Access Compliance Report Public Rights-of-Way (Curb Ramps)

Main Street: BRYNWOOD_LN Cross Street: FRANKLIN_WAY Location: NE

ADA ID: RPAT211104134450 Ramp Type: Type 4 - Parallel Initial Pass/Fail: Fail Overall Compliance: No Severity Score: 30

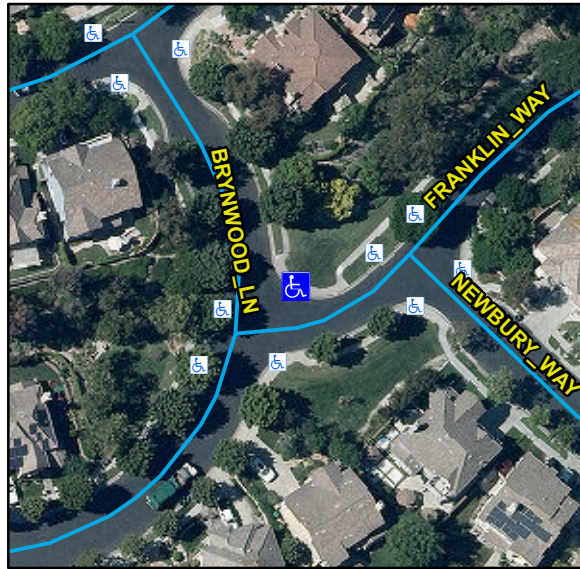
Compliance	Description	Data	Compliance	Description	Data
N/A	Ramp Length LT (in)	98	N/A	Ramp Length RT (in)	95
Yes	Ramp Width LT (in)	54	Yes	Ramp Width RT (in)	54
No	Ramp Run Slope LT (%)	19.9	No	Ramp Run Slope RT (%)	8.5
Yes	Ramp Cross Slope LT (%)	1.7	Yes	Ramp Cross Slope RT (%)	1.1
N/A	Landing Present	N/A	N/A	DWS Provided	N/A
N/A	Landing Length (in)	N/A	N/A	DWS Contrast	N/A
N/A	Landing Width (in)	N/A	N/A	DWS Length (in)	N/A
N/A	Landing Run Slope (%)	N/A	N/A	DWS Full Width	N/A
N/A	Landing Cross Slope (%)	N/A		DWS Offset Type	N/A
N/A	Landing Movement Obstructed?	N/A	N/A	DWS Offset Left (in)	N/A
	Landing Movement Type	N/A	N/A	DWS Offset Right (in)	N/A
N/A	Landing Shared	N/A			
N/A	Clear Space	Yes			
N/A	Clear Space To Crosswalk (in)	N/A			
N/A	Marked Crosswalk 1	No	N/A	Marked Crosswalk 2	No
	Crossing 1 Direction	S		Crossing 2 Direction	W
N/A	Marked Crosswalk 1 Width (in)	N/A		Marked Crosswalk 2 Width (in)	N/A

Remove & Replace Curb Ramp With Two New Directional Ramps or Equivalent.
